R-3867-2013 - DOSSIER GÉNÉRIQUE PORTANT SUR L'ALLOCATION DES COÛTS
ET LA STRUCTURE TARIFAIRE DE GAZ MÉTRO

RÉPONSE DE L'EXPERT PAUL CHERNICK
À LA DEMANDE DE RENSEIGNEMENTS N°1 DE LA RÉGIE DE L'ÉNERGIE

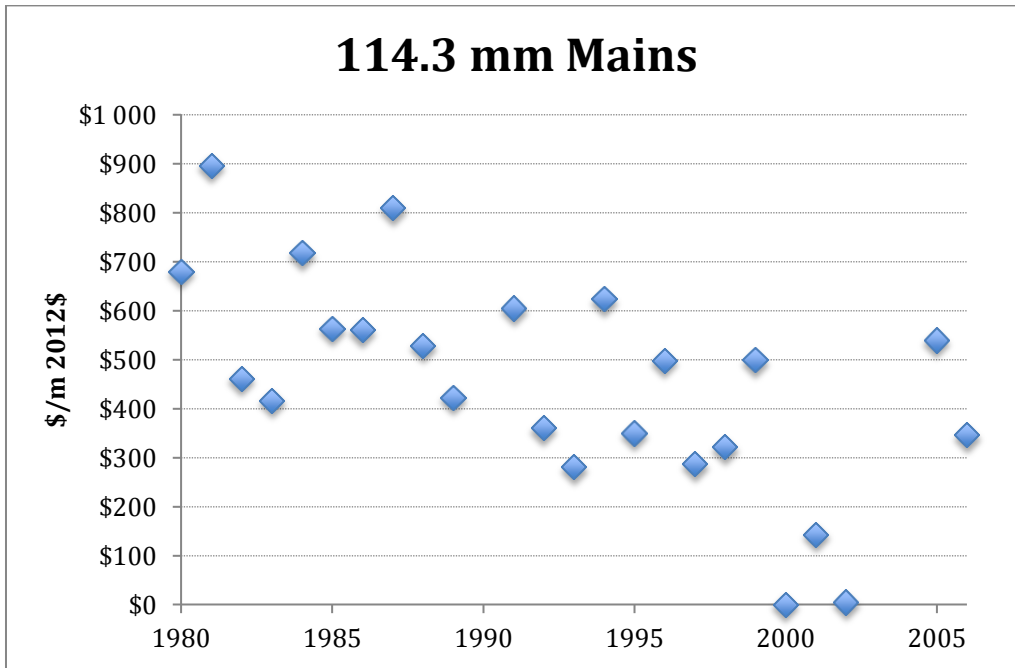
This problem is much more serious in Mr. Knecht's proposed approach, as a result of Mr. Knecht's proposal to reject Gaz Métro's use of the Handy-Whitman index. Mr. Knecht's position appears to be based entirely on the "sample" of cost data that he displays in his Figure Iec-1 (Document C-ACIG-0028, at 16–17), and specifically the indication in Figure Iec-1 that inflating the pre-1987 mains at the Handy-Whitman index results in higher prices in 2012 dollars for those mains than for the post-1987 mains. (Even in Mr. Knecht's figure, the costs in 2012\$ appear to be stable after about 1987.)

The figure below shows the full set of data for the 114.3 mm mains, which Mr. Knecht labels as 168.3 mm (the 168.3 mm mains are labeled as 219.1 mm in Figure Iec-1). By ignoring data after 1999, and costs under \$200/m, Mr. Knecht hides the

near-zero costs for 2000–2002, which demonstrate that something other than price trends affect Gaz Métro’s mains costs, and the costs for 2005–2006, which demonstrate that the costs inflated by the Handy-Whitman index were stable from 1988 to 2006.

The very low costs per metre reported for 2000–2002 suggest that some of the recent low prices have been the results of cost sharing by government grants or contributions from large customers served by the extensions. The higher earlier costs may reflect the absence of those cost reductions, as well as higher costs for construction in urban areas and unfavourable soil conditions.
